# Medium Delay and CR ERL

*Comments #113, #120*

**Amphenol Corporation**

**October 13, 2020**

Figure 162-2—100GBASE-CR1, 200GBASE-CR2 or 400GBASE-CR4 link

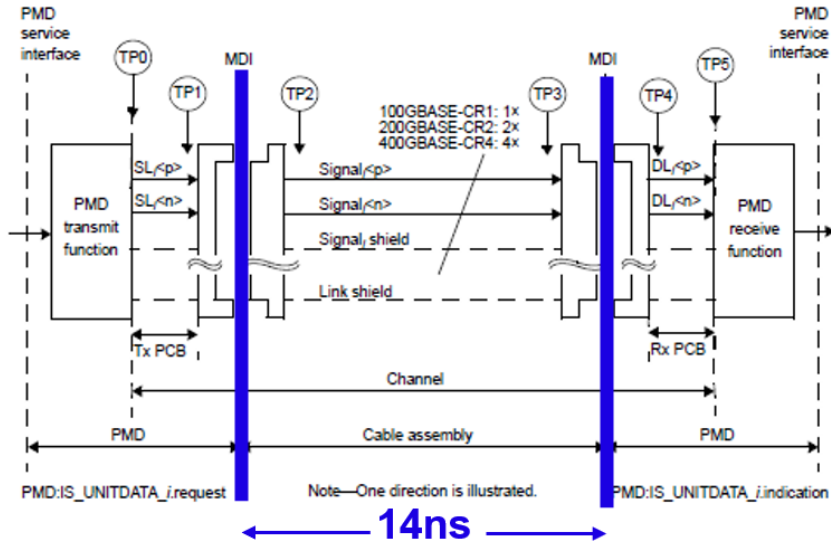
one-way delay no more than "14ns"

one-way delay no more than "16ns", for consistency with ERL parameter values

Based on contributed measurements (TP1-TP4) the one-way delay for a 2m cable is very unlikely to exceed a 14ns maximum delay

- Spec for 3cd “one-way delay thru medium” was 20ns
- POR for 3ck is 14ns
  - The delay attributed to the cable moving from 3m to 2m is ~5ns
  - **A more appropriate maximum delay for 3ck may be 15-16ns**

Figure 162-2—100GBASE-CR1, 200GBASE-CR2 or 400GBASE-CR4 link

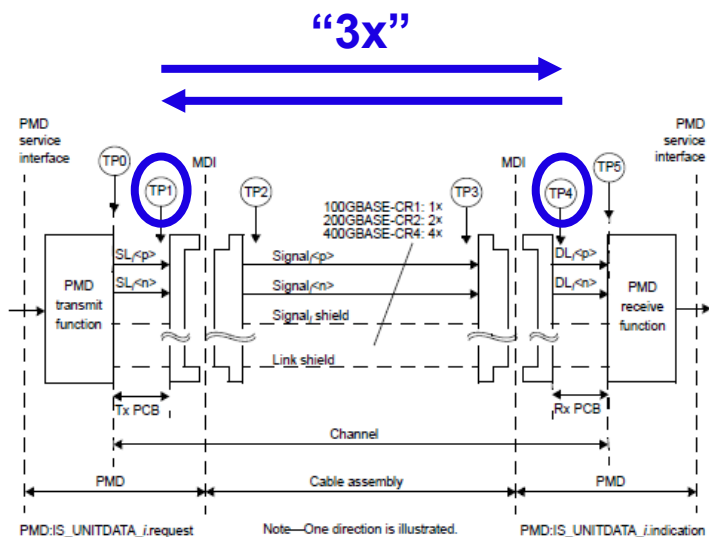
- Request for ERL calculation to define the length of the reflection signal as 3x the round-trip flight time (mellitz\_3ck\_01b\_0320)
- $N = fb * \text{"3x" round-trip delay}$
- $f_{\text{step}} = (\text{"3x" round-trip delay})^{-1}$

- One-way delay (TP1-TP4) is largely determined by the cable (medium delay)
- If one-way medium delay 16ns, then...
  - ...TP1-TP4 delay is ~16ns
    - ... then f\_step for CR compliance can be 10MHz
    - ... then a practical setting for N would be 5100
